Subject: RE: Windsor Forest Knolls Lot 8
From: "Williams, Jeffrey" <jewilliams@howardcountymd.gov>
Date: 9/23/2020, 2:36 PM
To: Alice Miller <amiller@bei-civilengineering.com>

Re: Windsor Forest Knolls
Lot 8

**AMENDED PERCOLATION CERTIFICATION PLAN
WINDSOR FOREST KNOLLS**
LOTS 1 THRU 18, BUILDABLE AGRICULTURAL PRESERVATION
PARCEL 'A', & ENVIRONMENTAL NON-BUILDABLE
PRESERVATION PARCELS 'B', 'C', & 'D'
A516478

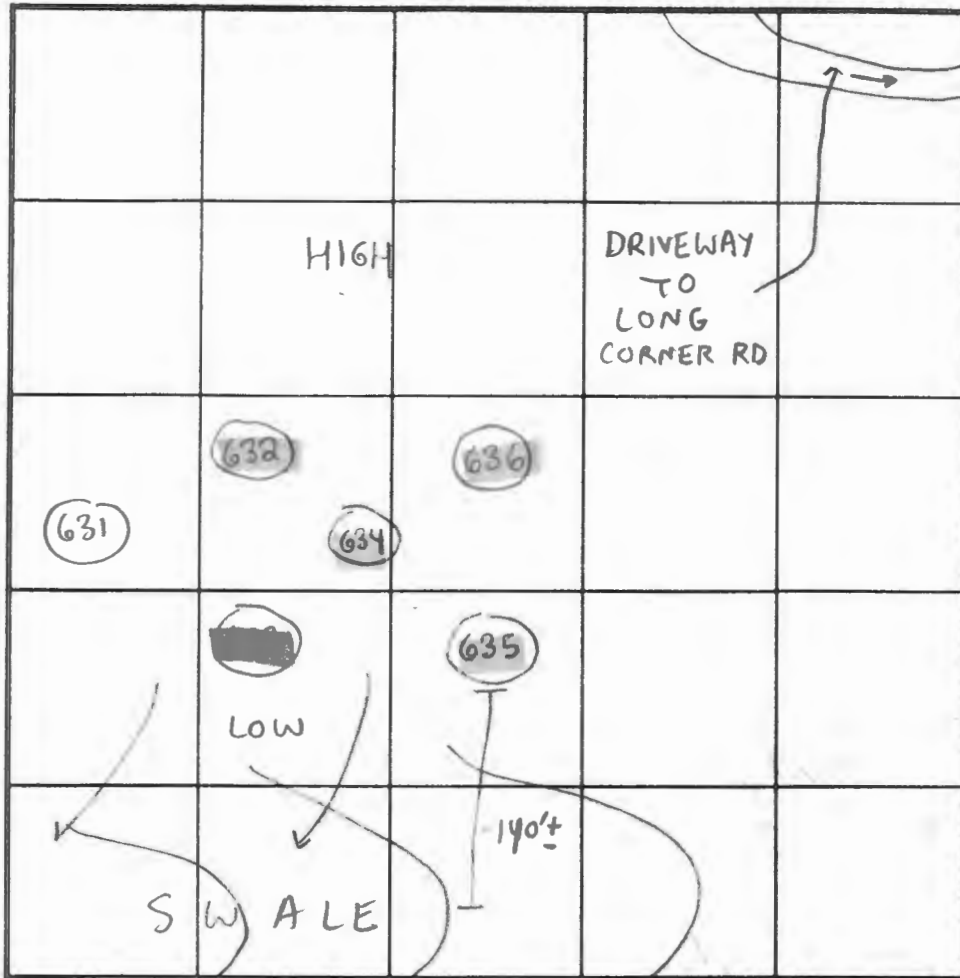
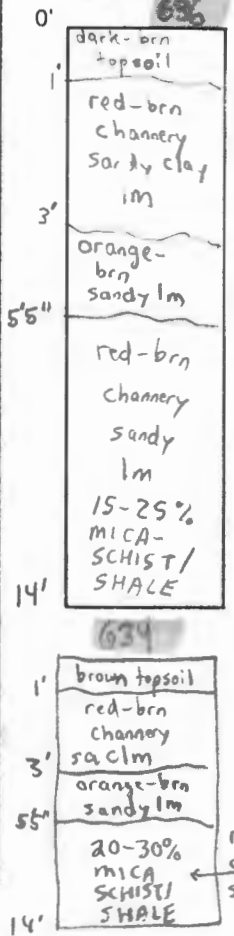
Looking at these perc notes, I don't see why the effective area can't start at 3'

Jeff - I'm hopeful that I will find some more lots that will just 'work' with the specs. However, here's another that did not, with the builder's proposed five bedrooms. My proposal moves the effective area 'up' to 4.0, rather than 4.5 as was indicated on the old specs. The tests for this lot did not evidence the typical clay layer that many of the other test locations had, so this might be acceptable. Please let me know what you think. I tried many layout options with the old specs, and just couldn't fit enough trenches into this very odd shaped disposal area.

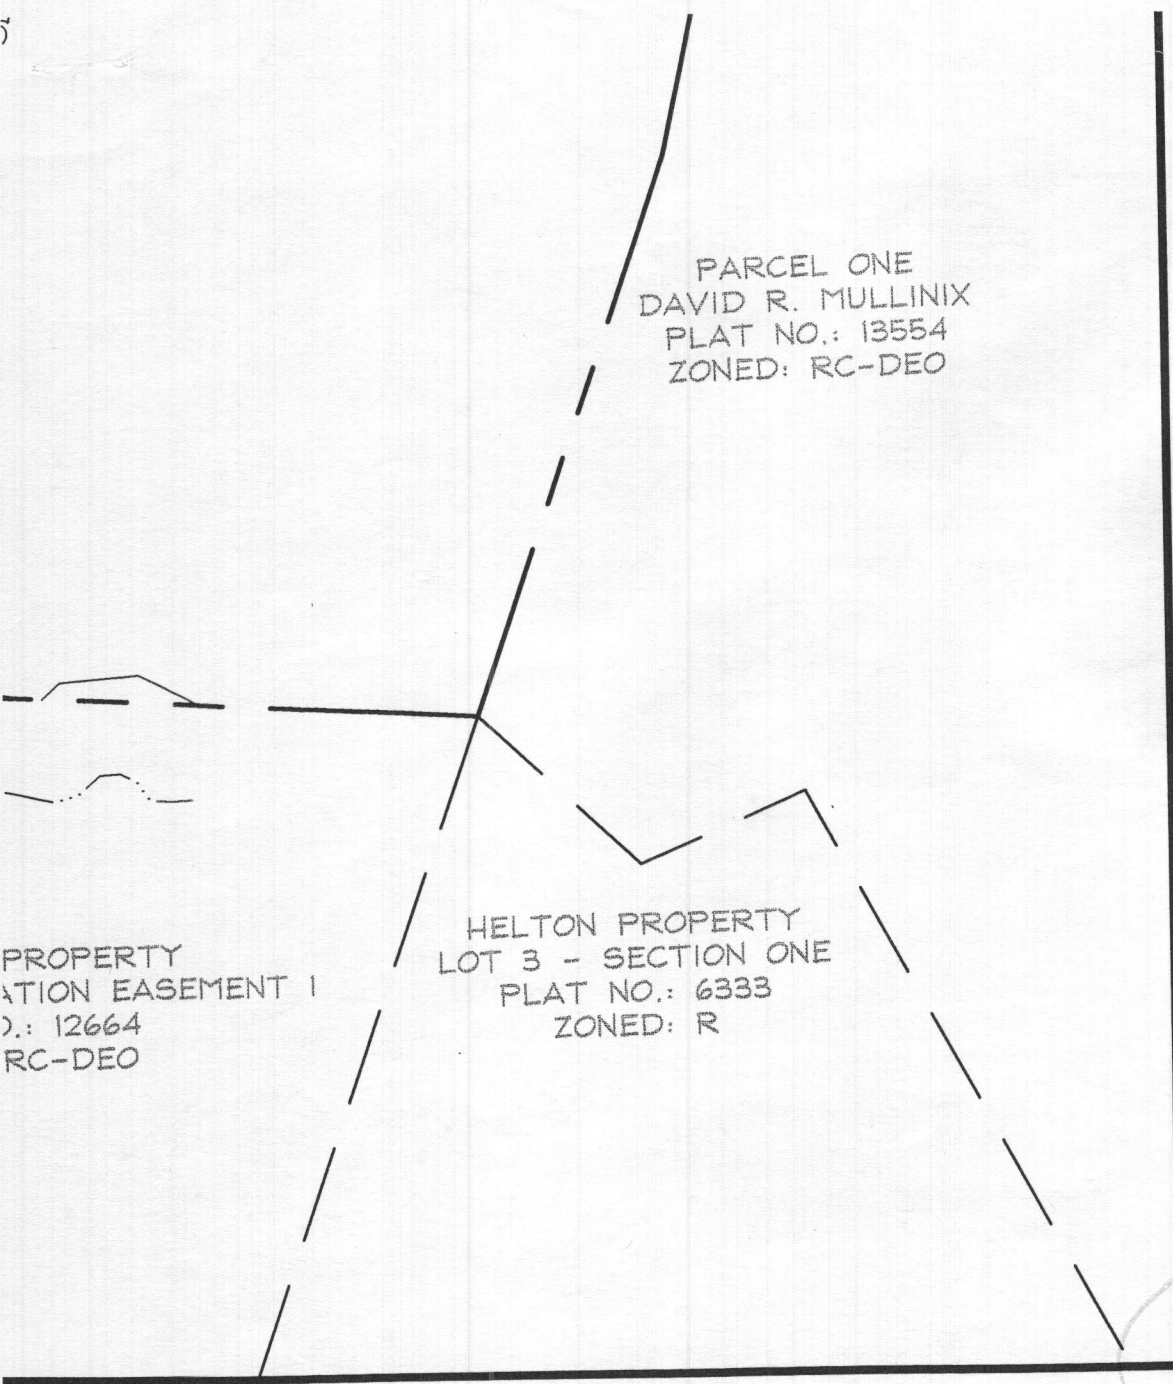
Maximize the separation of the well on lot 8 to the adjacent existing septic system NW of lot 8. The well **must** be drilled in the southwest corner (looking at the plan-upper/left corner) of the well box. The 200ft setback will not be maintained and other reasoning will follow behind this action.
